Development Review Committee Comments | 5/20/2025 Case PLAT25-0088 Greenway Parks (8851 Bud Jensen Drive)

WRITTEN STATEMENT OF CONDITIONS

EASEMENT ABANDONMENTS PRELIMINARY PLAT

GREENWAY PARKS

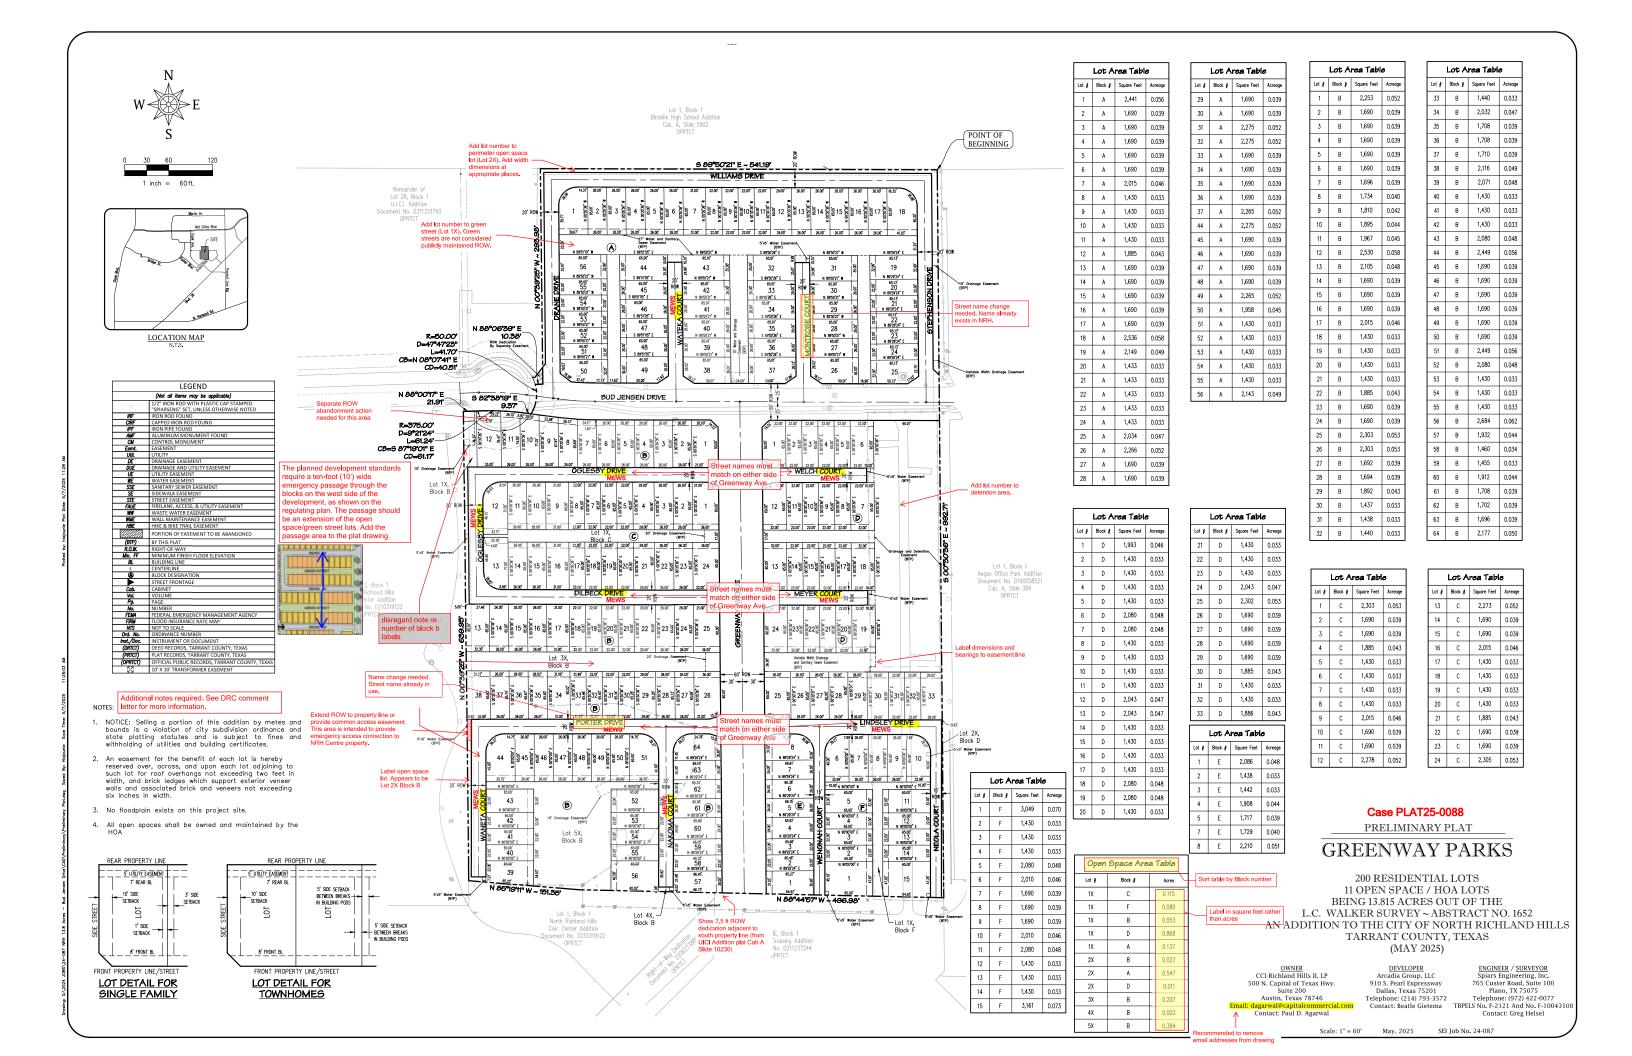
- 1. Revisions to proposed street names are noted on the marked-up drawing. Generally, street names should match on either side of Greenway Avenue, as different names could hamper the provision of public safety and emergency services. Street types (i.e., mews) should align with the approved regulating plan for the development. NRH Subdivision Regulations §110-201 (Requirements for all plat drawings street names)
- 2. Revise the Planning and Zoning Commission and City Council approval blocks as shown below. NRH Subdivision Regulations §110-203 (Additional requirements for plat drawings certification of approval)

- 7. Label the dimensions and bearings on the drainage and sanitary sewer easement line by Lots 19 and 29 Block D. NRH Subdivision Regulations §110-201 (Requirements for all plat drawings easements)

- 8. In Block A, add a lot number to the green street open space lot (Lot 1X Block A) and the perimeter open space lot north of Bud Jensen Drive (Lot 2X Block A). NRH Subdivision Regulations §110-331 (Requirements for all plat drawings lot and block numbering)

- 9. In Block B, add a lot number to the open space lot in the southwest corner of the property (Lot 2X Block B). NRH Subdivision Regulations §110-331 (Requirements for all plat drawings lot and block numbering)

- 10. In Block D, add a lot number to the open space lot that includes the green street and detention area (Lot 1X Block D). NRH Subdivision Regulations §110-331 (Requirements for all plat drawings lot and block numbering)

- 12. Show and label the existing 7.5-foot right-of-way dedication adjacent to the south boundary line. The right-of-way was dedicated on the UICI Addition plat recorded in Cabinet A Slide 10230. NRH Subdivision Regulations §110-257 (Street right-of-way dedication)

- 13. An emergency driveway connection between the NRH Center property and Porter Drive (as shown) is indicated on the regulating plan. Extend the street right-of-way to the west boundary line or provide a common access easement as noted on the marked-up drawing. NRH Subdivision Regulations §110-232 (Common access easements)

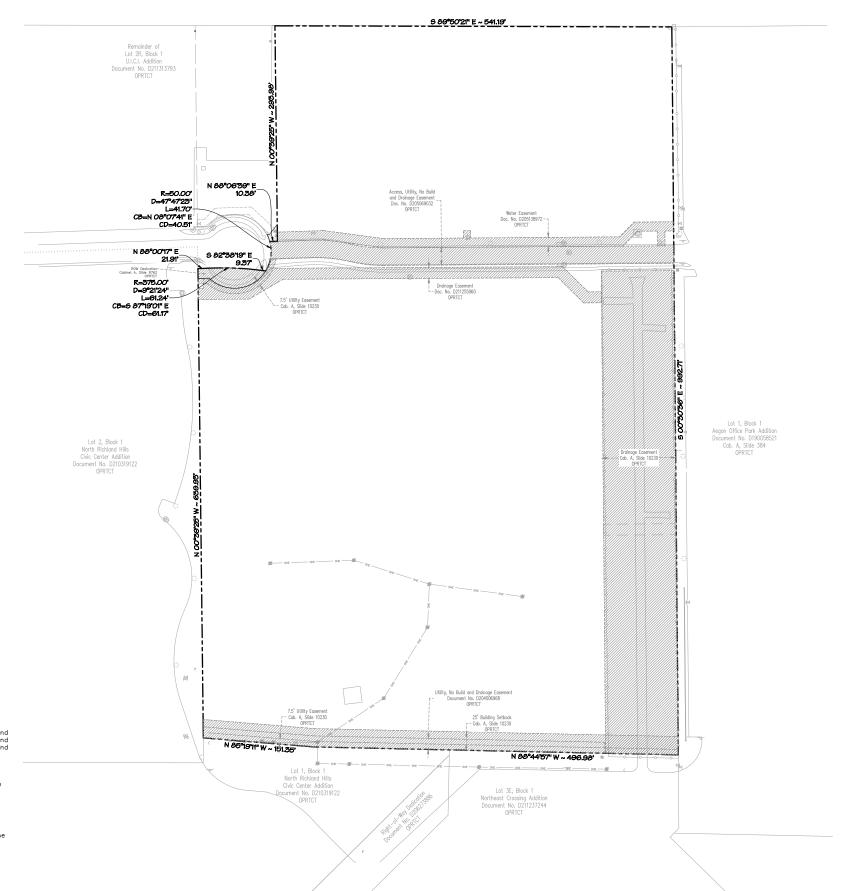
- 5. Add the following note to the plat: Above ground franchise utility appurtenances are not allowed in the fronts of the properties. NRH Subdivision Regulations §110-201 (Requirements for all plat drawings plat notes and conditions)

- 6. Add the following note to the plat: The easements indicated on this plat are for the purpose of constructing, using, and maintaining public utilities including underground conduits, manholes, pipes, valves, posts, above ground cables, wires, or combinations thereof, together with the right of ingress and egress to operate and maintain the public utilities. NRH Subdivision Regulations §110-201 (Requirements for all plat drawings plat notes and conditions)
